**AMENDED –  
URGENT FIELD SAFETY NOTICE**

GEHC Ref# 32067-A

RE: Giraffe Warmer/Panda iRes Warmer - Bedside panels or latch areas may be cracked, broken, or damaged.

Figure 1B: Area connecting panel to bed

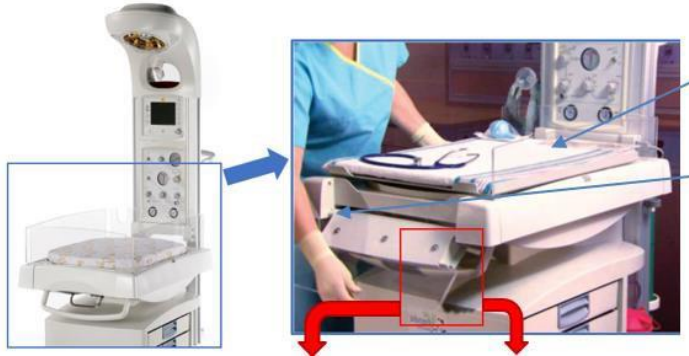
**BEFORE EACH USE OF THE DOOR PANEL:** Visually inspect for any cracks or damage to the beside panels, the latch area, and the area connecting the panel to the bed (see below Figure 1B). If any portion of the bedside panels or latches is damaged or cracked (see below Figure 1C), **stop use of the warmer.**

- If the Warmer bedside panels or latches have no cracks or damage, you may continue to use your warmer.
- Before every patient use and every time the walls are raised and lowered during routine patient care by all staff who interact with warmers, complete the following additional check:

- Inspect the operation of all three bedside panels: front (furthest away from the Healthcare Provider Control Panel) and both side panels and confirm that they lock securely in the upright position. Lowering a bedside panel should be possible only by pulling it up and then pulling the top edge away from the bed.

- If any of the bedside panels do not lock securely, replace bedside panel(s) before placing an infant inside the warmer. Move the infant to a warmer with fully functioning bedside panels. Do not place or leave an infant in a warmer with non-functioning bedside panels. Remove the warmer with non-functioning bedside panels from service until the bedside panel(s) can be replaced.
